**From:** <alan.lang@power.alstom.com>  
**To:** Phong Do <PHONG-D@ipsc.com>  
**Date:** 9/1/2004 7:55:58 AM  
**Subject:** Re: IP Clearance Data

**From:** <kevin.spires@power.alstom.com>  
**To:** Phong Do <PHONG-D@ipsc.com>  
**Date:** 7/15/2004 6:55:28 AM  
**Subject:** Re: IPSC IP Cooling Temperature Reduction

**INTERMOUNTAIN POWER UNIT 1 IP  
ROTOR COOLING STEAM ANALYSIS AND REPORT**

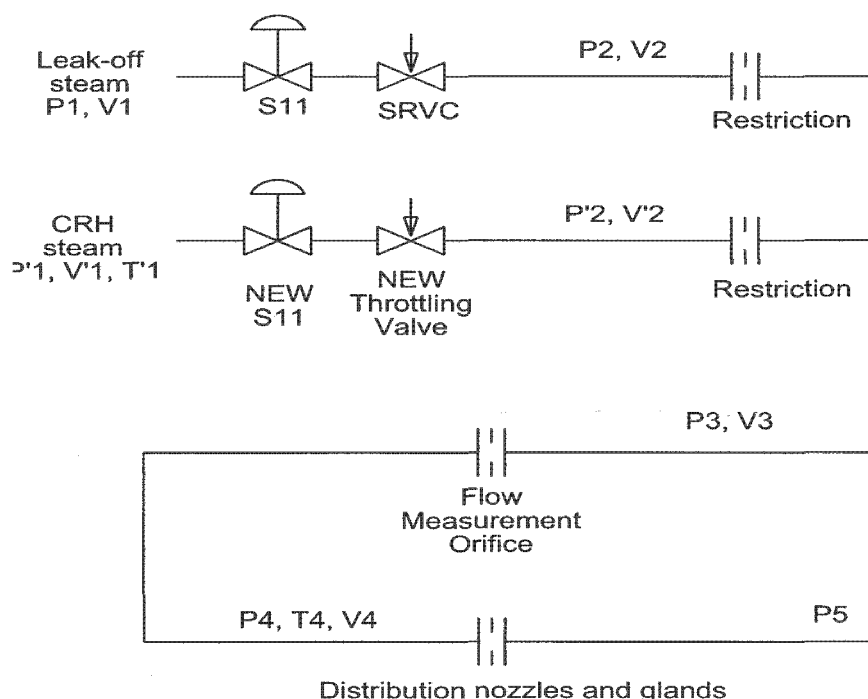
Following retrofit of the HP cylinder on Intermountain unit 1, excessively high temperatures have been observed at the first stage wheel of the IP cylinder. This is because of high enthalpy steam from the HP second stage tip seals being introduced into the leak-off cooling flow to the IP rotor cooling system.

A method of reducing the net steam temperature is proposed, which takes a measure of steam from the HP cylinder exhaust in such a way that the mixed steam temperature can be controlled to pre-retrofit levels.

The proposal observes the requirements for IP rotor warming from the gland sealing system by means of the introduction of a pneumatically operated valve which prevents cool steam from the HP cylinder from reducing the overall warming effect. This valve will be operated by the same pneumatic signal as GE valve S11.

## Pneumatic Valve Data Sheet (Parallel Slide Type)

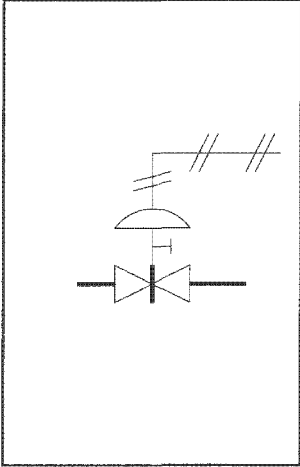
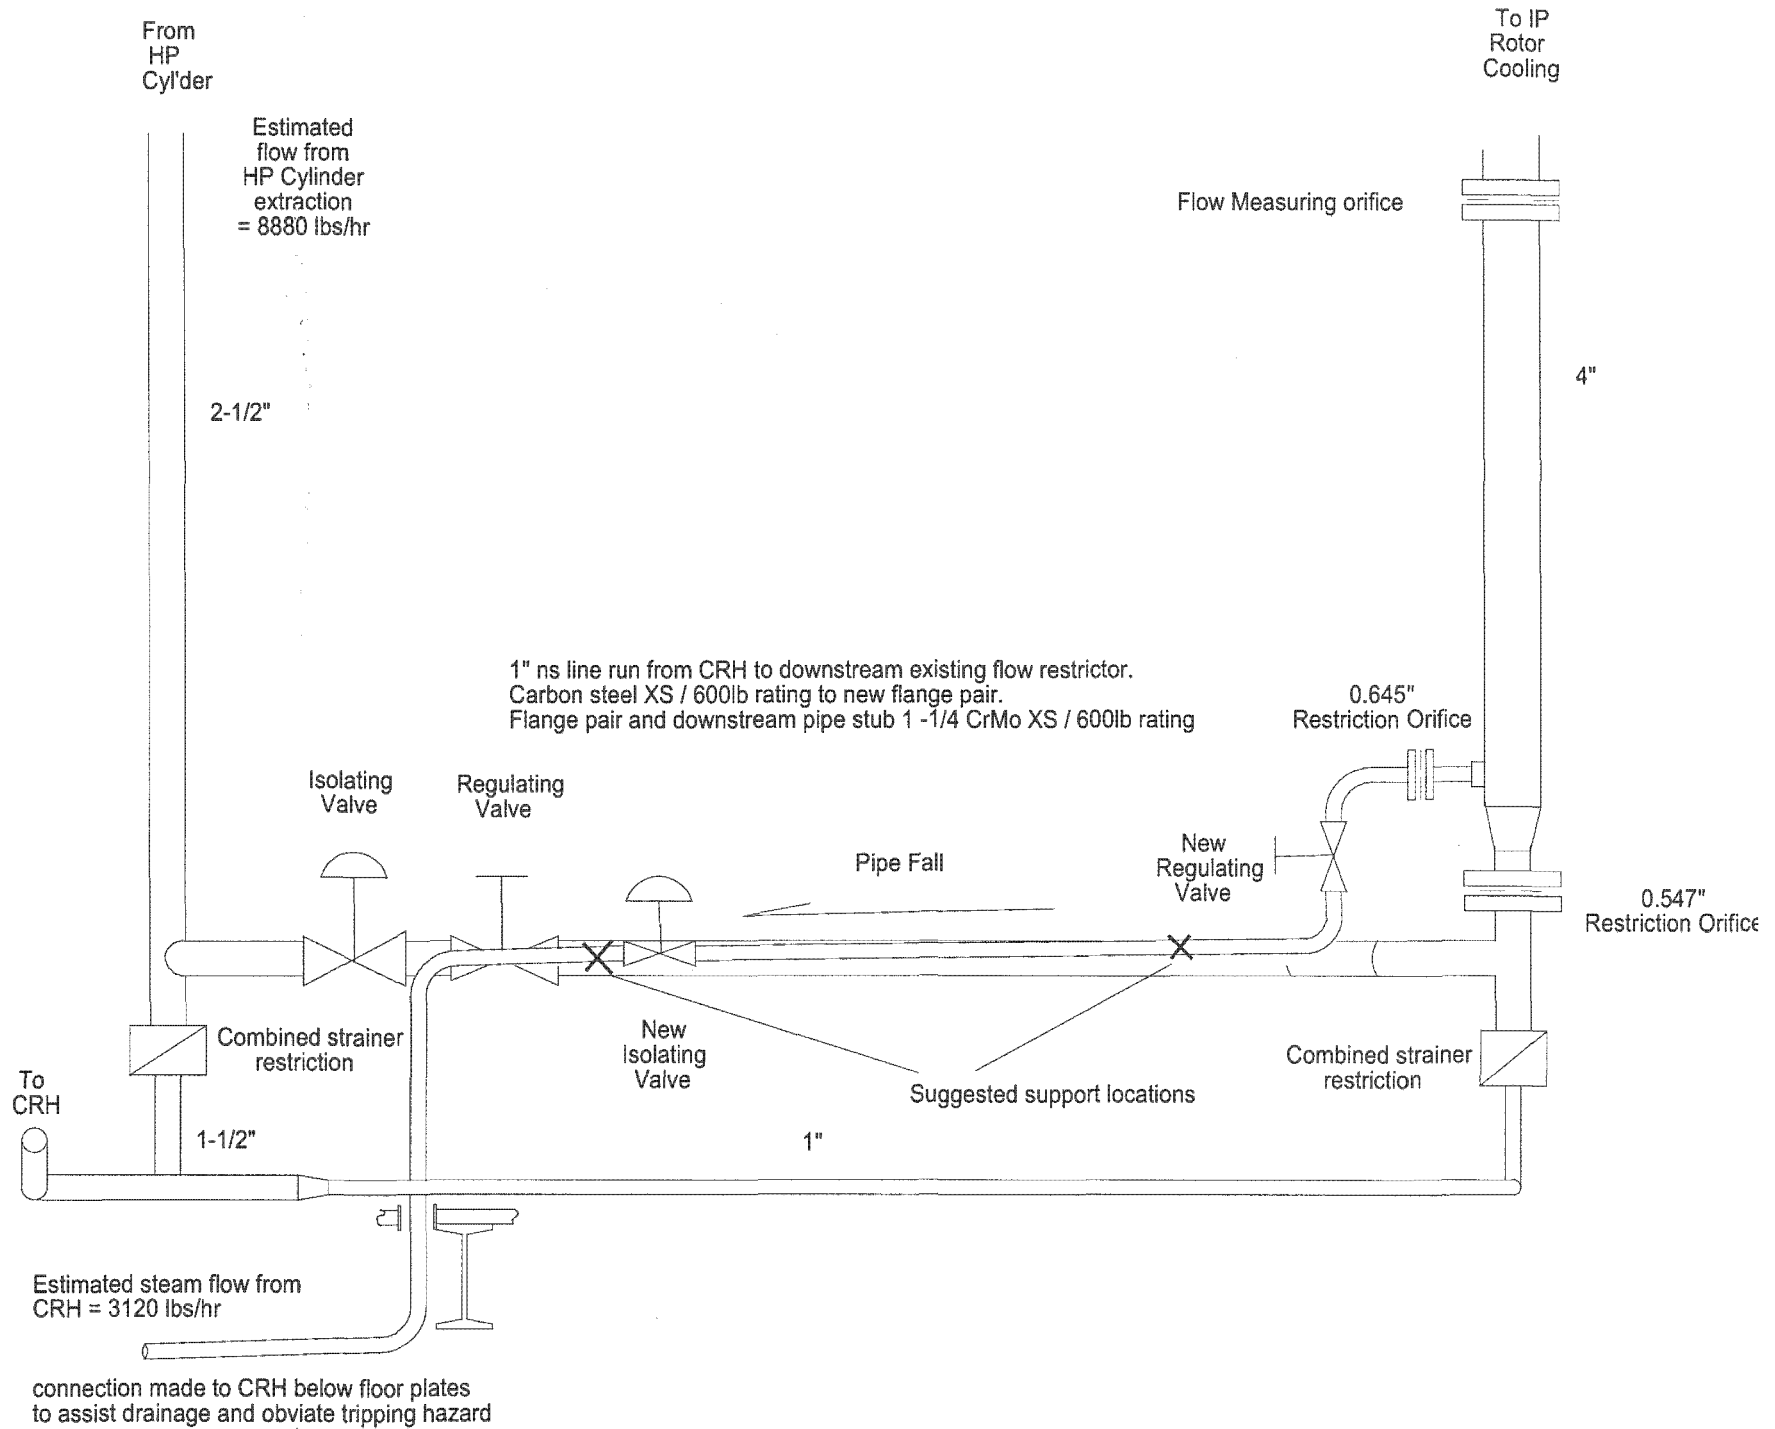
If I am correct on the above assumption then I foresee no problem. If, however, S11 is programmed to open before the HP cylinder depressurises then there may be a drainage problem and we may need to consider a drain orifice to bypass the new pneumatic isolating valve.

Note also, do you believe it would be necessary to supply this valve with limit switches? These could be arranged in parallel to the limit switches on S11 to signify correct operation.

We propose to use a parallel slide gate valve as this will require less operating force than a globe valve - is this OK?

It is my personal opinion that a parallel sliding gate valve should be adequate for your application.
